Rezoning #2020-00002
Development Special Use Permit #2020-00010
1101 Janney's Lane – Douglas MacArthur School

Application	General Data	
Project Name: Douglas MacArthur Elementary School	PC Hearing:	September 1, 2020
	CC Hearing:	September 12, 2020
	If approved, DSUP Expiration:	March 12, 2024
	Plan Acreage:	5.29 acres
Location: 1009, 1101, 1201 and 1203 Janney's Lane (school site) 1099 Francis Hammond Parkway (Forest Park)	Current Zones:	R-8, R-20 Single-Family Residential and POS Public Open Space
	Proposed Uses:	Public School and Recreation Facilities
	Gross Floor Area:	163,435 square feet
Applicant: Alexandria City Public Schools (ACPS) and City of Alexandria	Small Area Plan:	Taylor Run / Duke Street
	Historic District:	n/a
	Green Building:	LEED Gold / Net Zero Ready

Purpose of Application
Consideration of a request to replace the existing Douglas MacArthur School with a new school building, below grade parking and recreational amenities.
Amendments, Special Use Permits and Modifications Requested:

Staff Recommendation: APPROVAL WITH CONDITIONS
Staff Reviewers: Robert Kerns AICP, Division Chief, Planning & Zoning, robert.kerns@alexandriava.gov Dirk H. Geratz, Principal Planne

Graphic #2: Proposed Zoning

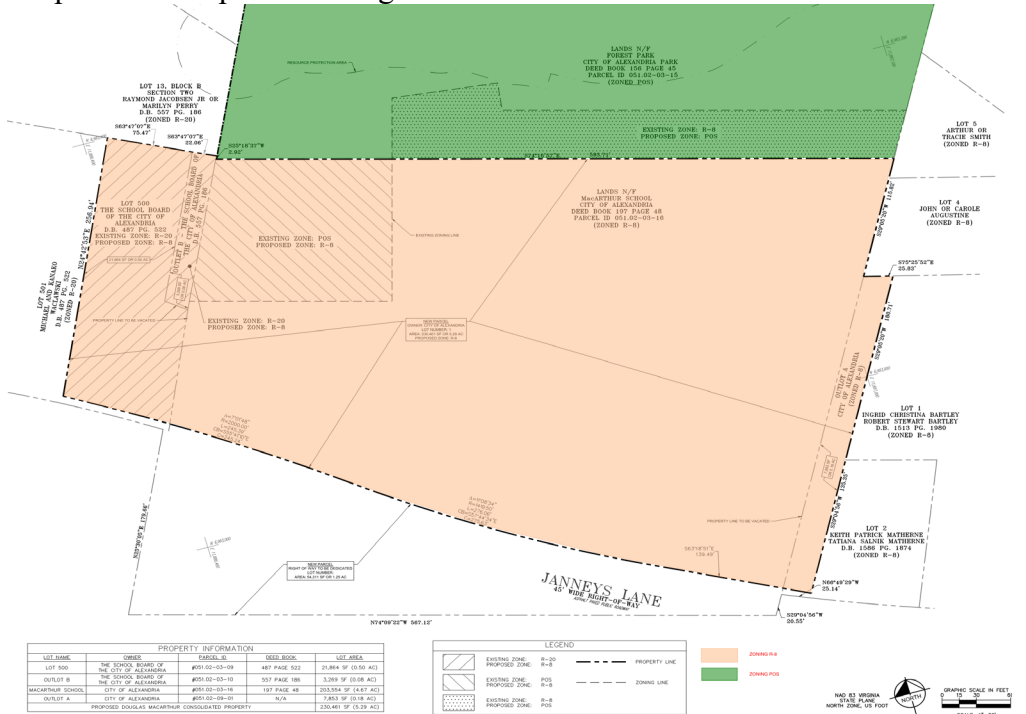
In March of 2015, ACPS received approval of a rezoning that was the result of a Special Use Permit to place mobile classrooms on the school site to address the need for more space. At the time the school building extended beyond the school property into Forest Park. The mobile classrooms planned to be located adjacent to this part of the school and within Forest Park. The approach taken at that time was to re-subdivide the property so the portion of the school extending into the park and the mobile classroom would become part of the school lot, transferring 20,681 feet from the “park lot” to the “main school lot”, with a rezoning of that transfer area from POS to R-8. The subdivision also transferred an equivalent 20,681 square feet of open play area on the “school lot” to the “park lot,” rezoning that transfer area from R-8 to POS to ensure that there would be no net loss of park land to City residents. The associated SUP for the mobile classroom and the subdivision have both since expired. However, the rezoning was adopted and needs to be corrected as part of the current request. Essentially, the proposed rezoning reverses this transfer and further includes the addition two lots west of the school site (see attached graphics #1 and #2 depicting before and after the rezoning).
